Access Compliance Report Public Rights-of-Way (Pedestrian Signals)

Main Street: **ORANGE_AVE** Cross Street: **BROOKHURST_ST** Location: **NE**

ADA ID: **SGRK220218193800** Signal Type: **One Push Button-Non APS** Overall Compliance: **No** Severity Scores: **BTN 1: 10** **BTN 2: N/A** **No BTN: N/A**

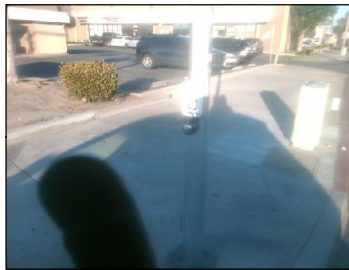
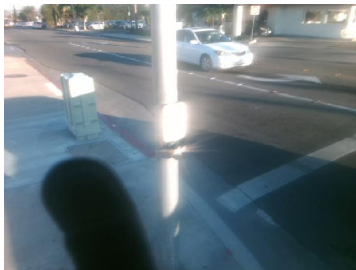
OC Std/PROW: **R404.3, MUTCD 4e.08**

Possible Solutions: Replace Signal Push Button With APS Button. Provide PAR As Indicated.
